TITLE:	WELDED LOCKER FLOOR PLANS

PENCO PRODUCTS • OAKS, PENNSYLVANIA	
PROJECT: CHESTERTON HIGH SCHOOL	
LOCATION: CHESTERTON, INDIANA	
ARCHITECT:	
CONTRACTOR: R.A. SNEEMS CONSTRUCTION CO.	
DRAWN BY: KEN MCCARRON	DATE: 7/30/98
CHECKED BY:	
DATE:	
SCALE: NOT TO SCALE	
ORDER NO.: C98M26829-37	SH: 1 OF: 7
DWG. NO.: 26829--37

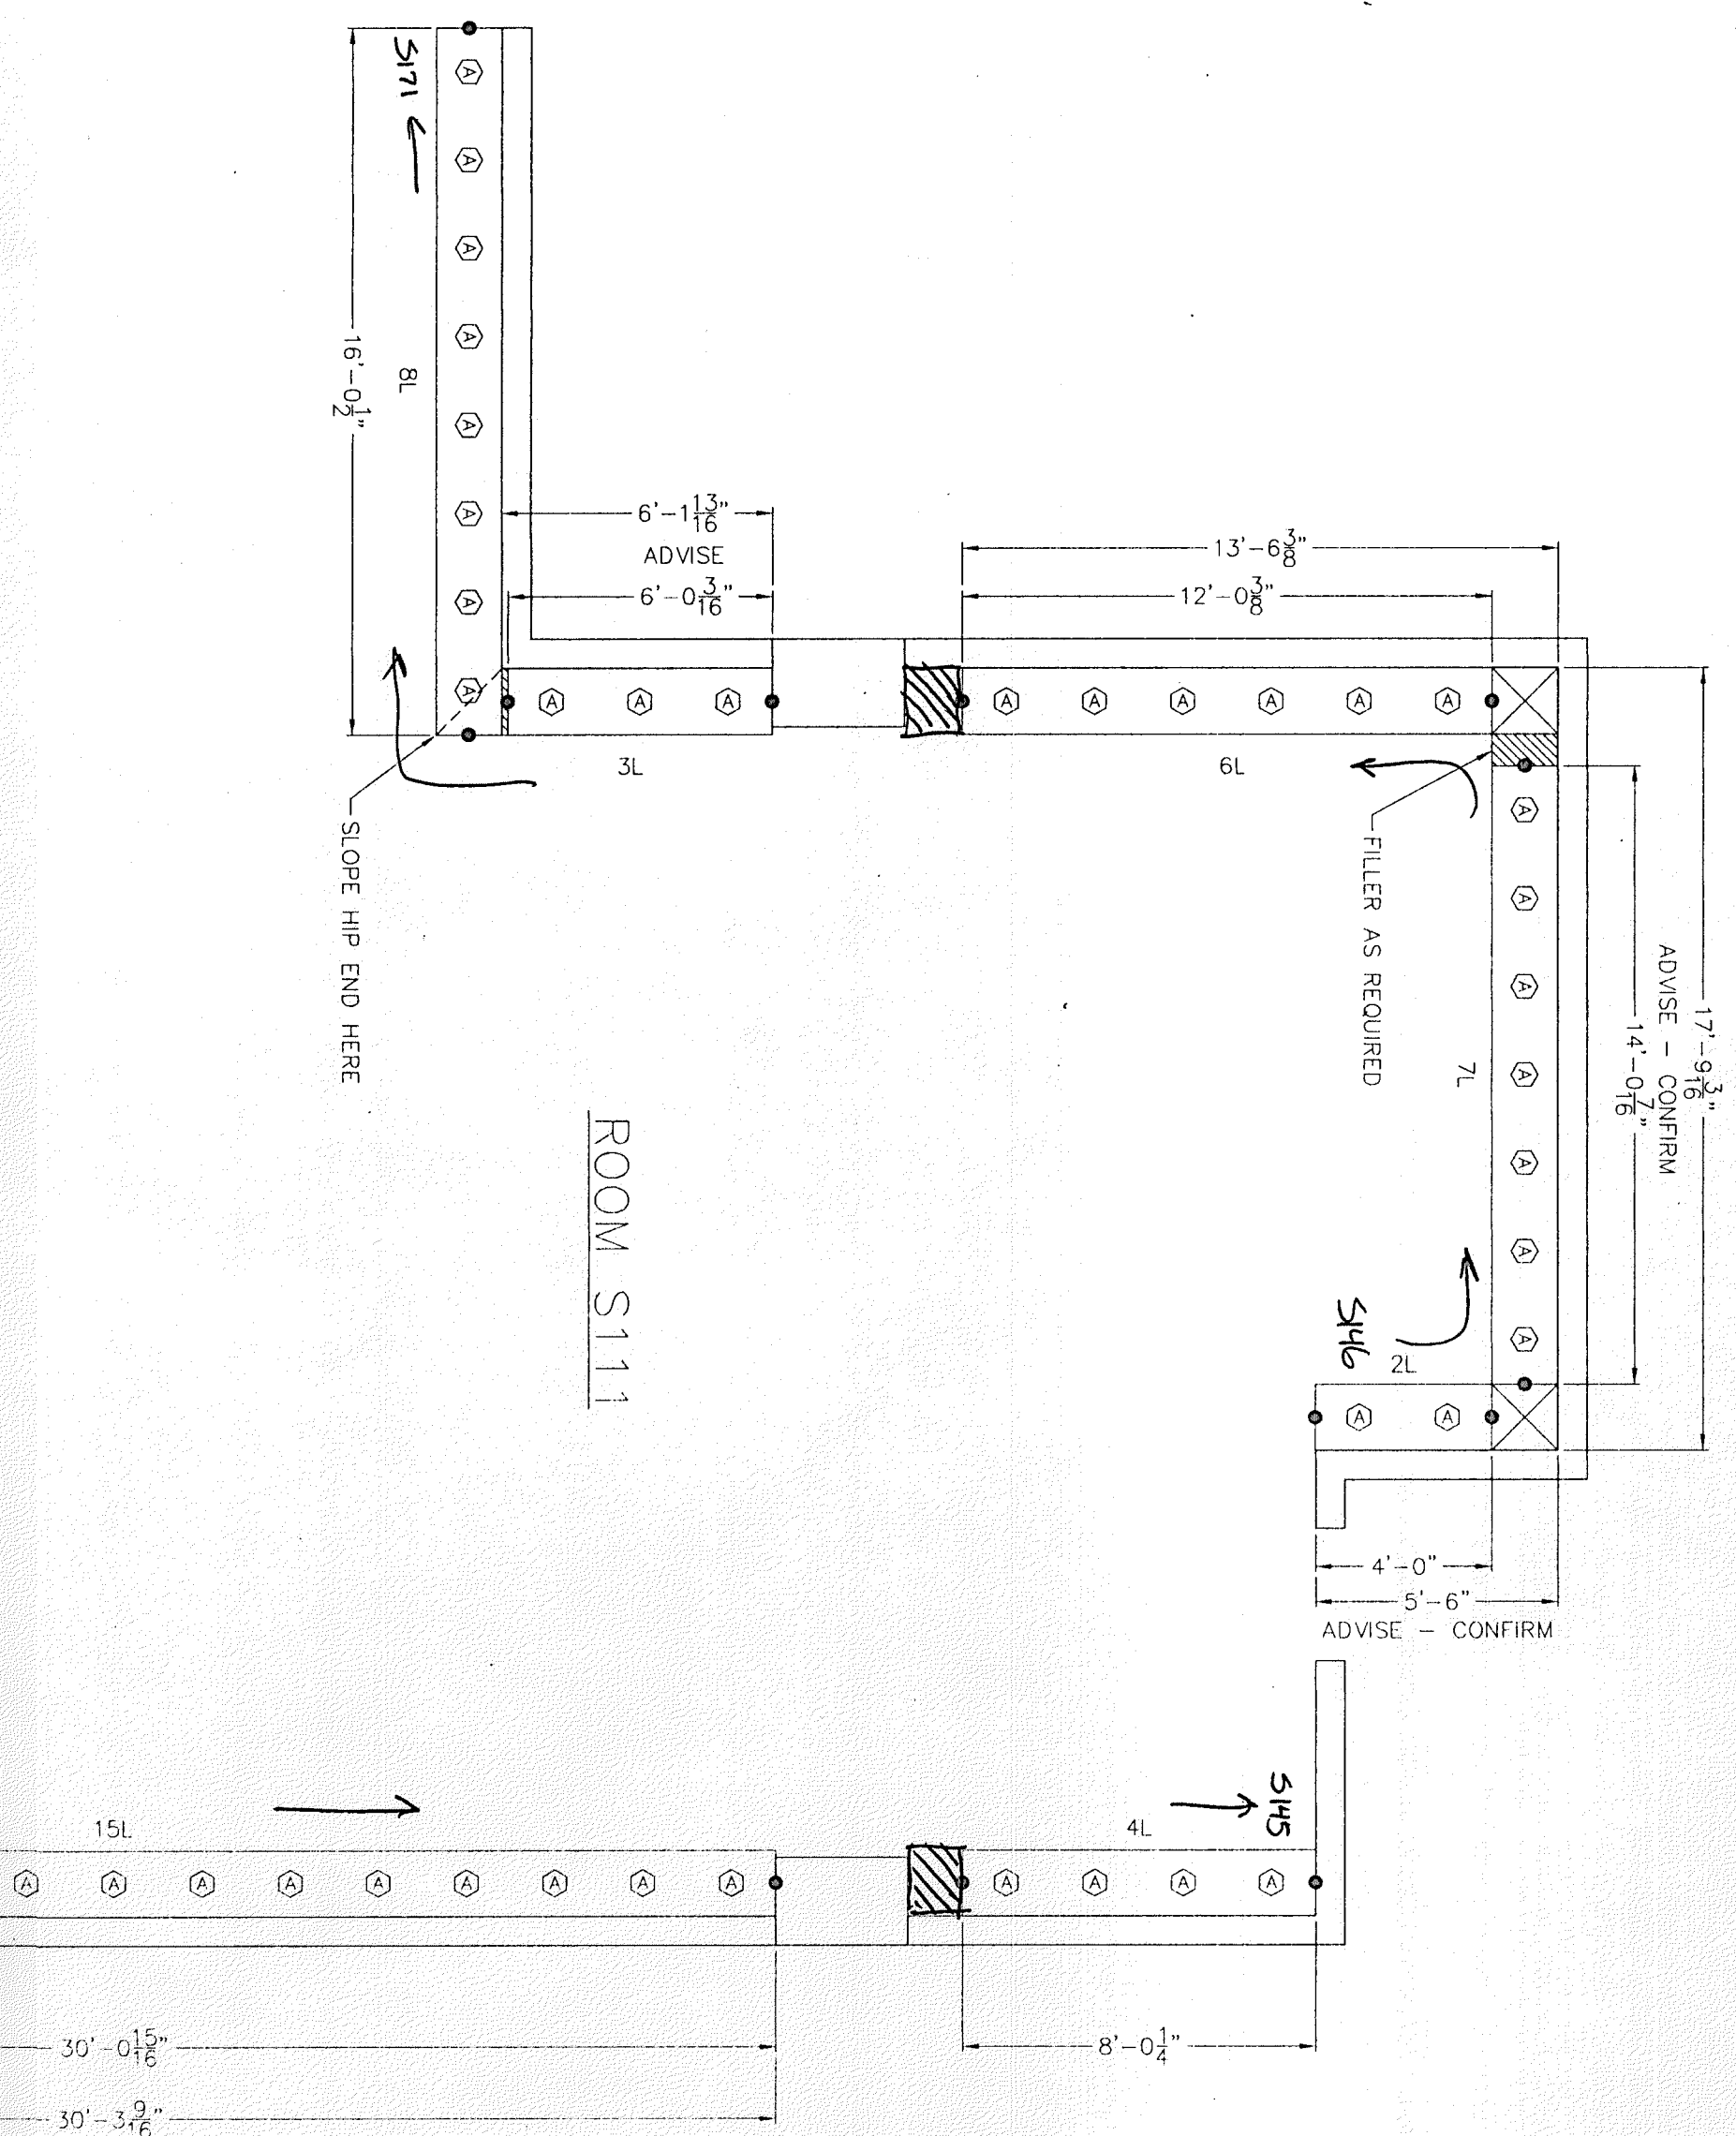
REQUIRED		FIELD CHECK:	1
1	REVISE PER G.C.	K.M.C.C.	1/28/99
REV	REMARKS	BY	DATE
